Fin Bangla Apparels Ltd.

72, Degarchala Road, Chaydana, National University, Gazipur
(23.963968N, 90.384676E)

31th July 2017

Discrepancies between provided drawing and on site condition of Main building

Ground floor roof beam layout in provided drawing

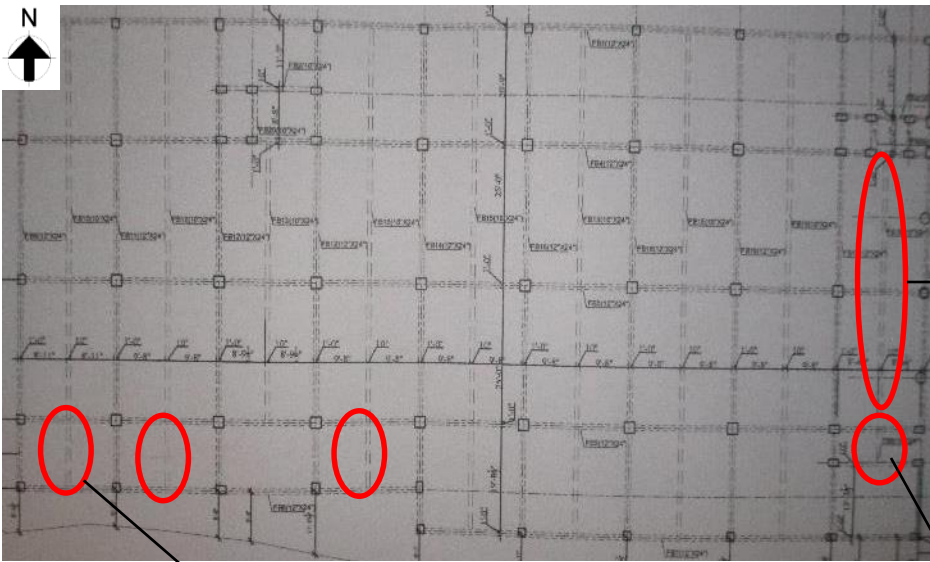
Secondary beam was not observed on east side loading/unloading area

Building Engineer required to prepare As –Built drawings reflecting the actual condition.

Typical floor beam layout in provided drawing

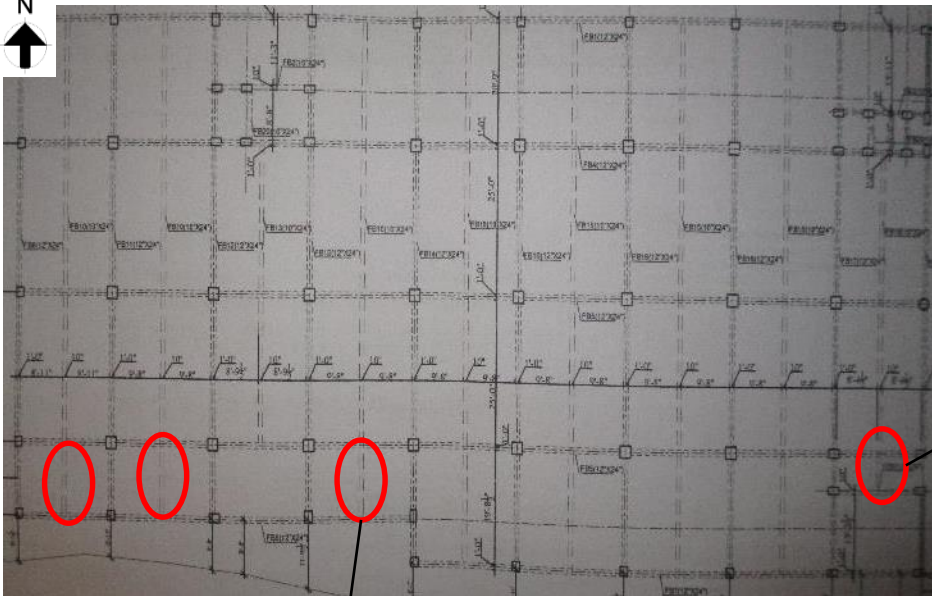
Secondary beam was not observed on east side toilet area on 1st to 3rd floor

Secondary beam was not observed on south-west side on 1st to 3rd floor
